DP-21-22 City of Bloomington Redevelopment Commission

CASE #: DP-21-22

BLOOMINGTON PLAT COMMITTEE STAFF REPORT

RE: City of Bloomington Plat Committee - Proposed Lot 2 Subdivision for the Trades District Technology Center

TRADES DISTRICT *PROPOSED* AMENDMENT 2 PLAT

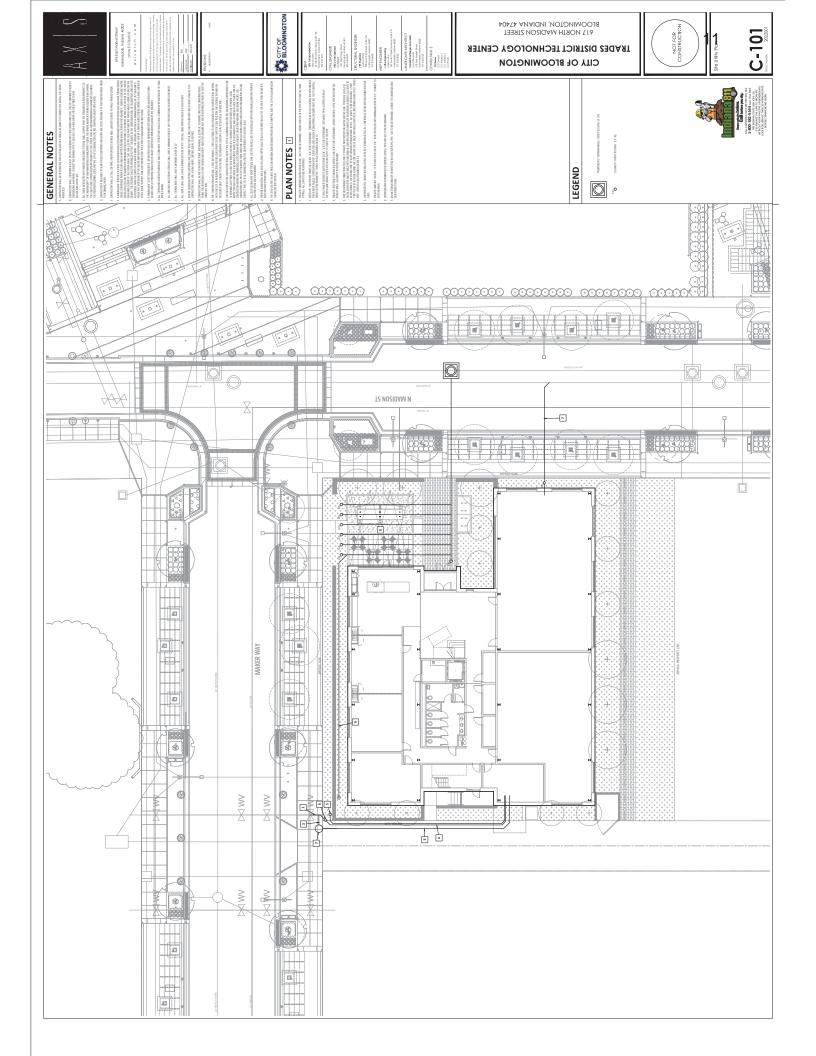
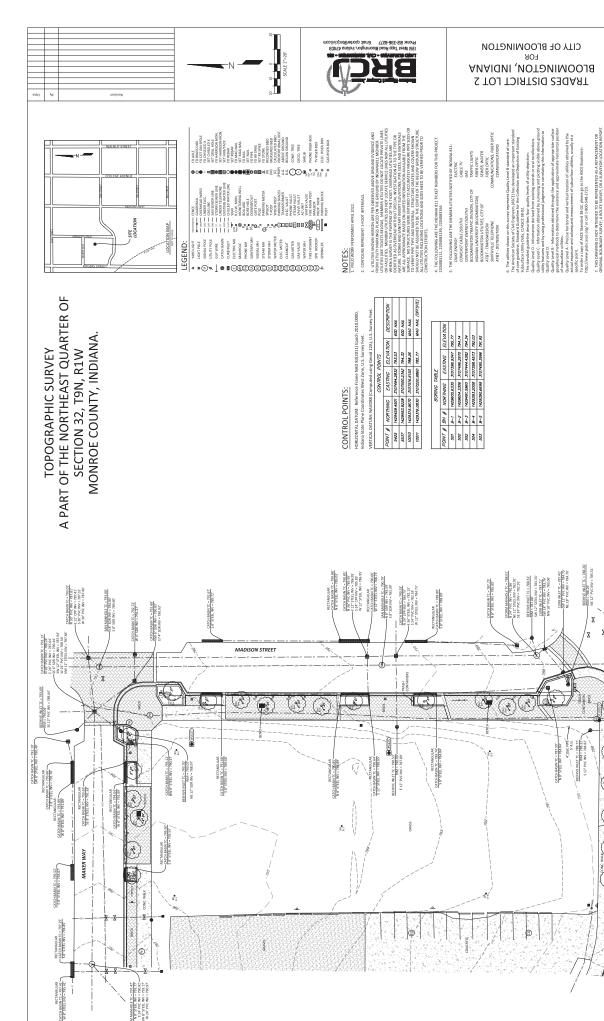
- 1. The secondary plat will be delegated to staff approval.
- 2. The labeling for the non-tangent curve near the eastern corner of Lot 6 will be moved on the secondary plat so that it is legible.
